RESPONSE TO COMMENTS
BHP Billiton Navajo Coal Company - Navajo Mine
NPDES Permit No. NN0028193

EPA received one set of comments from the San Juan Citizens Alliance, Diné Citizens Against Ruining our Environment (Diné Care) and the Clean Air Task Force. Incorporated by reference was the report titled: *A Preliminary Evaluation of the Potential for Surface Water Quality Impacts From Fly Ash Disposal at the Navajo Mine, New Mexico* D. A. Zimmerman, P.E., SETA, May 20, 2005. EPA has summarized and responded to significant comment below.

Figure 11. Topographic map showing zone representing "downstream of the mine."

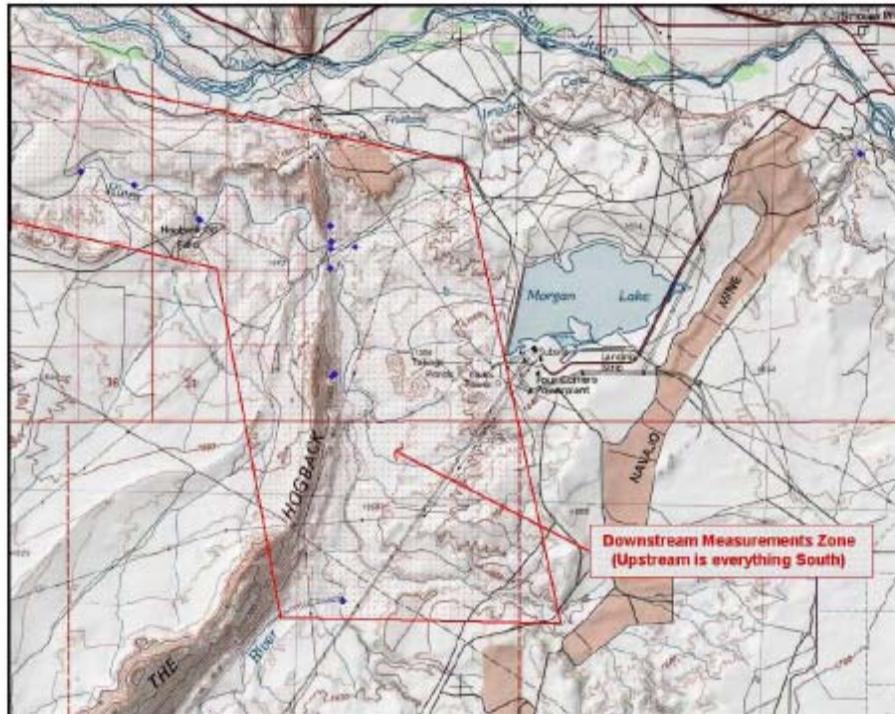
EPA generally agrees that comparing downstream and upstream boundaries to assess water quality is a viable approach. Collected data at designated boundaries was visually illustrated on Figure 11 and 12. However, two issues resonate from the report's assessment of spatial monitoring data; the lack of a clear border between upstream and downstream clusters and its rationale, and the disparity of sample sizes between upstream and downstream data sets per analyte. As mentioned previously, there were no clear justifications behind the separation of the two monitoring regimes. Based on Figure 12, there is an obvious disparity between utilized upstream and upstream monitoring points. The upstream regime for TDS data depicted in Figure 12 illustrates an overwhelmingly large area and pool of monitoring points in respect to downstream regime. The disparity can affect the results of the t-test since the two groups are not approximately balanced.

Third, EPA evaluated the physical locations of the upstream and downstream data and potential sources of impacts to the watershed. As noted above, the report defines “upstream” and “downstream” measurement zones as presented in two topographic maps, Figures 11 and 12 (pages 24, 26 respectively). Neither of these maps gives explicit geographical coordinates for the selected sites nor provides scales to assess distances and positions. Unlike Figure 11, Figure 12 does not provide a landmark point of references, i.e. geological formations (Hogback), waterways (San Juan River, Chaco River, and Morgan Lake), industrial operations (Navajo Mines, Four Corners Power Plant, and agricultural project sites), etc. Therefore, EPA has been able to reconstruct only a general description of the report’s presentation of upstream and downstream data.

As indicated, Figures 11&12 are diagrams of the Chaco Basin that have pooled downstream monitoring points. The downstream monitoring area covers roughly 44,000 acres (177 km²), and is located directly west of the mine site. Estimated area is based on Zimmerman’s aerial topographic map seen in Figure 11 and regenerated on Google Earth Pro (4.2.0205.5730) as seen in Figure A. A toolkit from the program positioned relevant landmarks (i.e. permitted outfalls) to their geographical coordinates and determined approximate distances among interested landmarks, i.e. outfalls, hydrologic features, monitoring stations, industrial operations, etc.

Zimmerman’s downstream boundary consists of Leasing Area I and II of BNCC which comprises Outfalls 001, 002, 004, 006-011 as seen in Figures A and B. Outfalls 006-011 neighbor ephemeral washes at close proximities of 60-760 feet (18-152 m). Services roads for haulage and fords transect and interrupt some washes that tributary to Chaco River.

Figure 12. Map of water quality monitoring stations with TDS values plotted. Note that use of average values for USGS station 09367950 biases to the low side, the overall downstream average (see red line and plotted points in Figure 10).

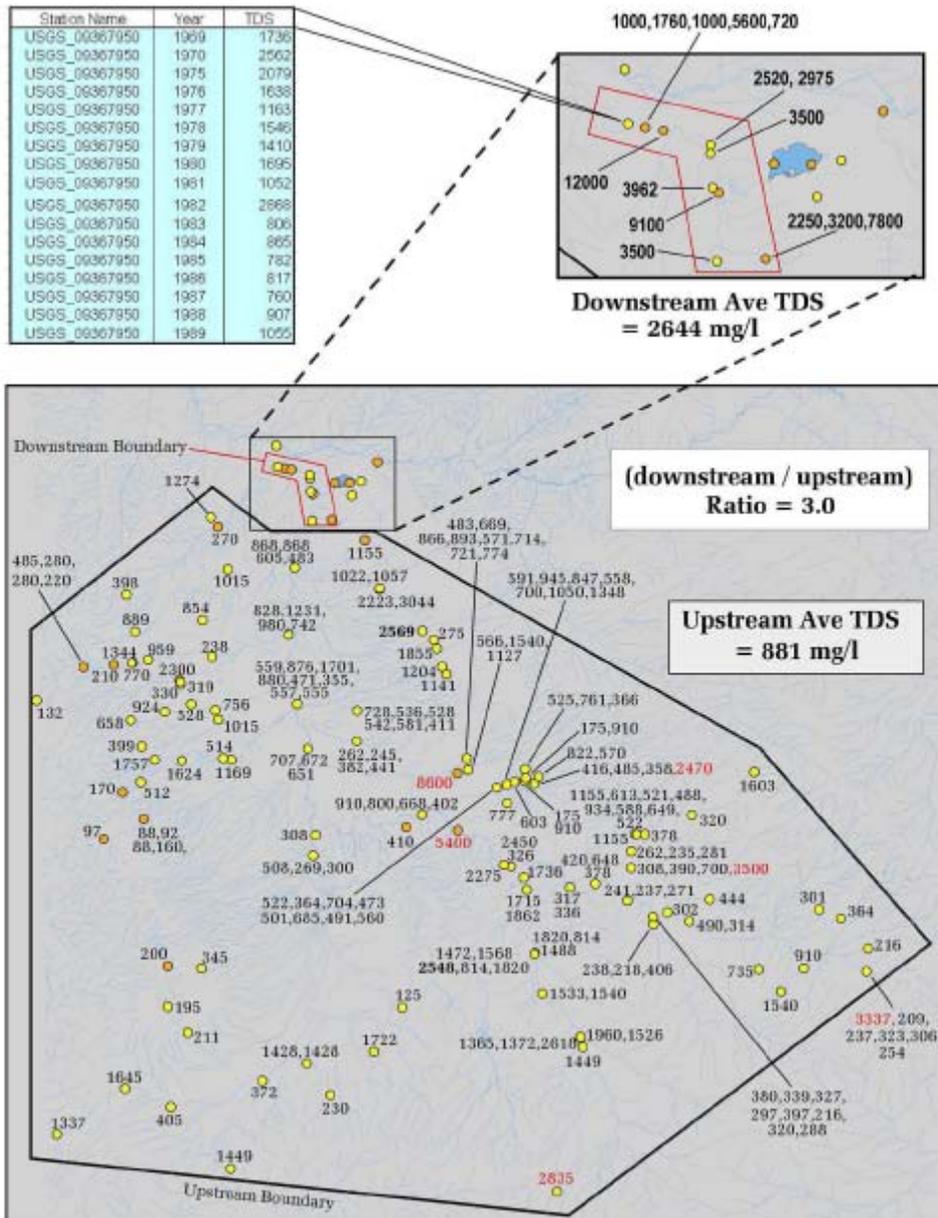
As seen in Table A, upstream data points predominated data collected downstream at varying ratios. This disparity is physically depicted in Figure 12 by its plotting of pooled upstream and downstream monitoring for TDS. Congruency for downstream and upstream stations layout of TDS to other listed analytes was not mentioned. It is also noted that the report did not specify if

In addition, based on Figure 12's TDS data, EPA noticed that the t-test was done incorrectly. The averages used in the statistical t-test should be discrete values. All 32 TDS results are not discrete because of the temporal correlation within each station with multiple results over time. The degrees of freedom in the test should be from $n=9$ downstream stations, not $n=32$ temporally correlated results.

As an example, Figure 12 presents a map of the downstream TDS concentrations. There are 9 separate sampling locations. Five of the sampling locations have only 1 sample for TDS, while one of the sample locations has 17 samples for TDS. One monitoring site in the downstream

area ranged from 720 to 5,600 mg/l of TDS over 5 samples, while the range for the entire data set was from 760 mg/l to 12,000 mg/l. The Zimmerman report summed the total of all data points and divided by the total number of samples, regardless of considerations such as sample location (e.g., middle of the river vs. shallow area prone to higher sediment concentrations) and time of sample (e.g., if the sample was taken during a low flow event when TSS is low or during a rain event when TSS would expected to be high). Given the extreme variability of results, ranging from 760 to 12,000, an average value as presented in the Zimmerman report is of limited utility to compare to another highly variable data set (e.g., the “upstream” data) and is highly dependent on the number of samples taken, the time of the sampling, and the location of the sampling stations.

Upstream measurement area is defined as “everything South”. Figure 12 portrays the upstream regime which is many times larger than the downstream area. EPA generated Figure C conveys “everything South”, however quantitative boundary assessments were difficult to reproduce. Based on Figures 11 and A, EPA hypothesizes land south of Outfall 010 acted as a demarcation point between downstream and upstream boundaries. EPA could not extract discernable landmarks or cartographic features from Figure 12 to estimate land area or perimeter approximations. However, we crudely estimated 3.17 million acres (12814.7 km²) and of over 80 miles (128.75 km) lengthwise and widthwise segments of the boundary for a general comparison. Figure D depicts sectioned upstream regime that includes landmark features such as remaining outfalls in Leasing Sites III and IV; Outfalls 013, 016, 017, and 018. No records of discharges from these outfalls exist.

Figure E. Estimated downstream and lower upstream boundaries with geographically positioned outfalls and NNEPA monitoring stations with most exceedances.

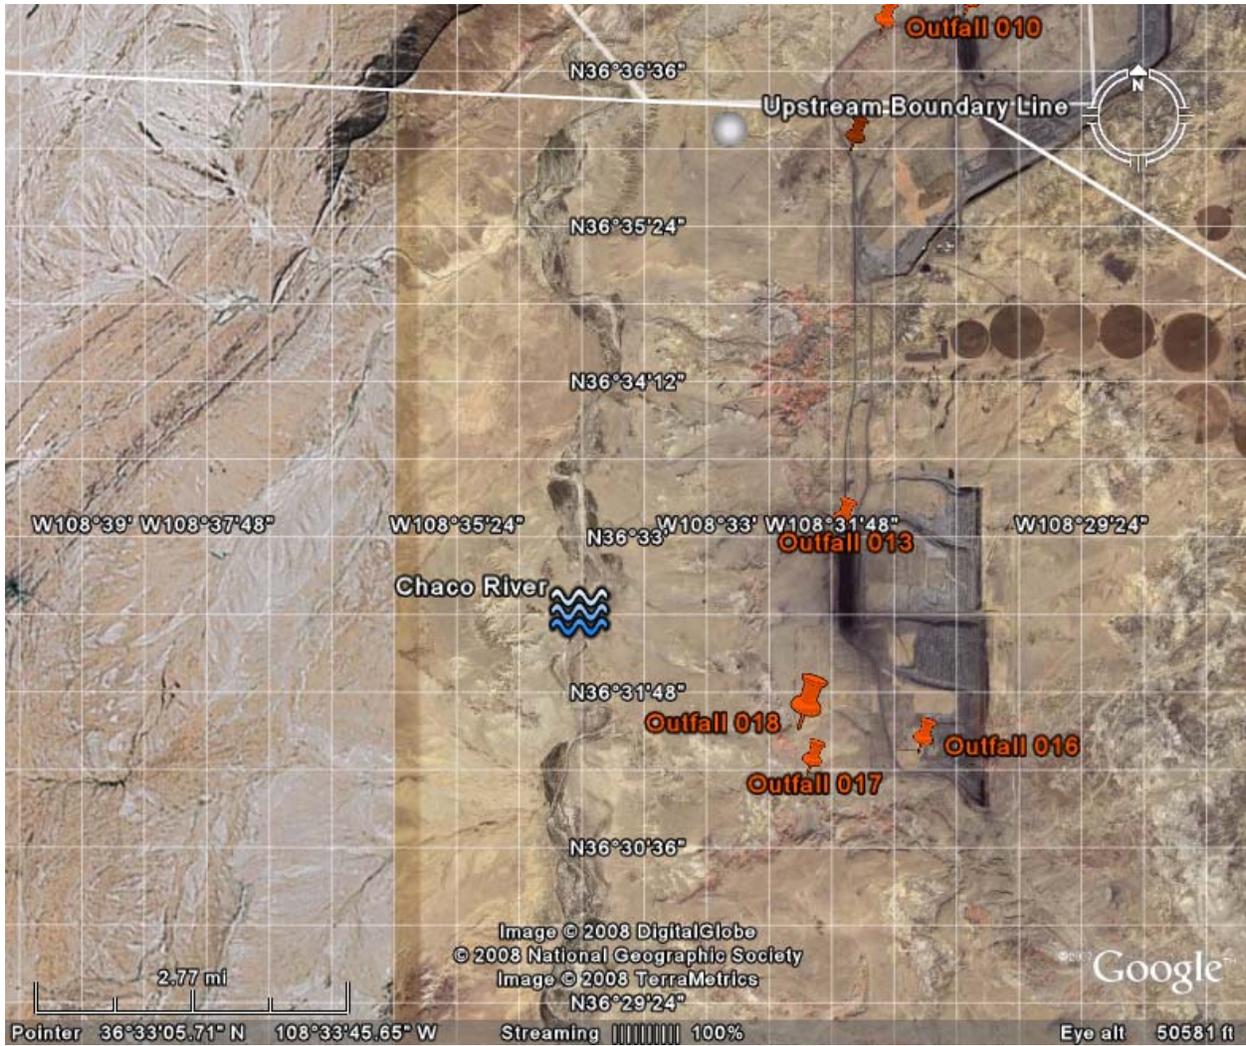
Navajo Nation Environmental Protection compiled data exceeding surface water quality constituents across 35 sites for over 8 years within San Juan Basin under agency sponsored monitoring programs. These sites included upper and middle San Juan River (i.e. Bitsui Wash, Ojo Amarillo Wash, Gallegos Wash, etc) and Chaco Wash (Chaco River, Chinde Wash, Sanostee Wash, etc). NNEPA tallied a total of 274 exceedances at Basin monitoring stations. The top three most frequented contaminants were total residue chlorine (TRC) ($n=42$), selenium ($n=29$), dissolved selenium ($n=28$) and the top three sites with most frequent exceedances were Ojo Amarillo Canyon ($n=64$), Gallegos Canyon ($n=55$), and North Chaco River ($n=53$). Ojo Amarillo and Gallegos stations are located approximately 6 and 18 miles east, respectively, of the mining site and are heavily influenced by NAPI activity and runoff. NNEPA Northern Chaco River monitoring station (06CHACORI01) neighbors Four Corners Power Plant and its mine tailings heap at approximately 6 miles (9.66 km) and 4.25 miles (6.84 km), respectively. The mine tailings heap neighbors Chaco River at approximately 1.0 miles (1.61 km). In addition, adequate baseline data is necessary to assess net impact from industrial activity to natural geological background. Images of mentioned outfall, NNEPA monitoring sites and their

comparative distances are provided in Figures E and F. EPA notes that Four Corners Power Plant resides within the downstream boundary and is in close proximity to Chaco River and a downstream NNEPA Chaco River monitoring station.
